DEVELOPMENT APPLICATION ASSESSMENT REPORT

Application Number:	DA2024/0604
----------------------------	-------------

Responsible Officer:	Simon Ferguson Tuor
Land to be developed (Address):	Lot 49 DP 7593, 19 Alleyne Avenue NORTH NARRABEEN NSW 2101
Proposed Development:	Alterations and additions to a dwelling house
Zoning:	C4 Environmental Living
Development Permissible:	Yes
Existing Use Rights:	No
Consent Authority:	Northern Beaches Council
Land and Environment Court Action:	No
Applicant:	Marjoleine Backer

Figure 1. Western elevation side envelope breach, as indicated in red.

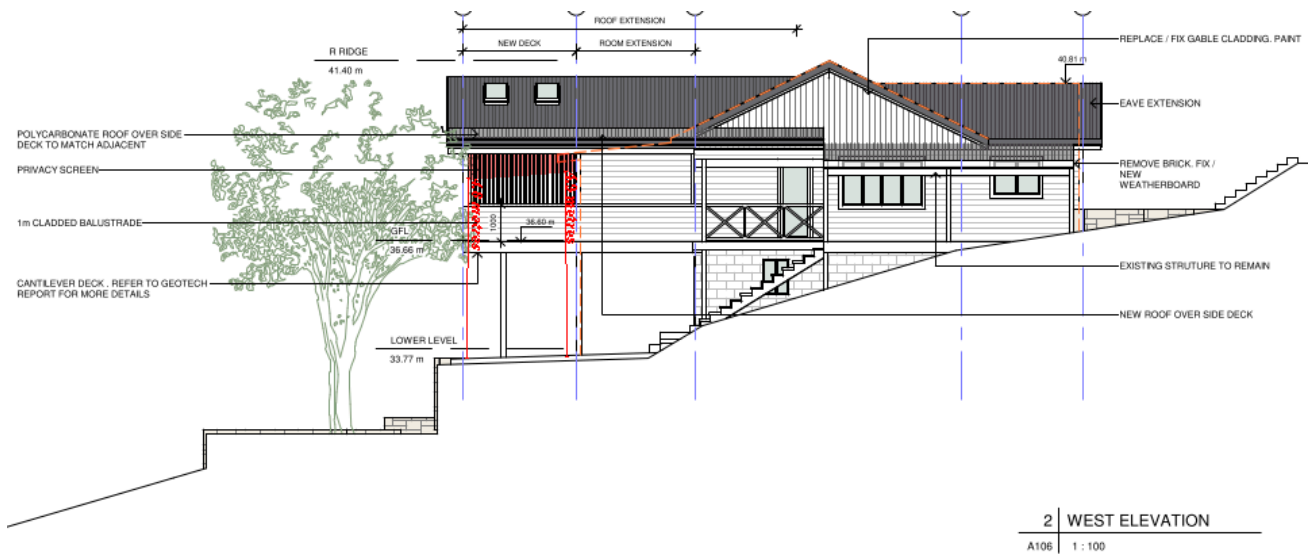
The proposed alterations to the dwelling extend beyond the prescribed side boundary envelope along the western and eastern elevations, as shown in the figures below.

The proposed rear deck extension is minor in nature and a significant amount of the envelope breaches are a result of the proposed privacy screens. Notwithstanding, there are no unreasonable amenity impacts upon adjoining properties, or the street frontage, that arise as a result of the extent of non-compliance to this control. The proposal achieves the desired future character of the North Narrabeen locality.

The proposal seeks to construct a rear deck addition 3m further towards the rear boundary than the existing built form. The proposal complies with height requirements and front and rear setbacks. The proposal is minor in nature and the envelope breaches are consistent with neighbouring sites which constrained by the steep site topography. In this instance, the built form of the proposal (including the privacy screens) is reasonable and appropriate in the context of the subject site, with minimal impacts upon adjoining properties.

Having regard to the above assessment, it is concluded that the proposed development is consistent with the relevant objectives of P21DCP and the objectives specified in s1.3 of the Environmental Planning and Assessment Act, 1979. Accordingly, this assessment finds that the proposal is supported, in this particular instance.
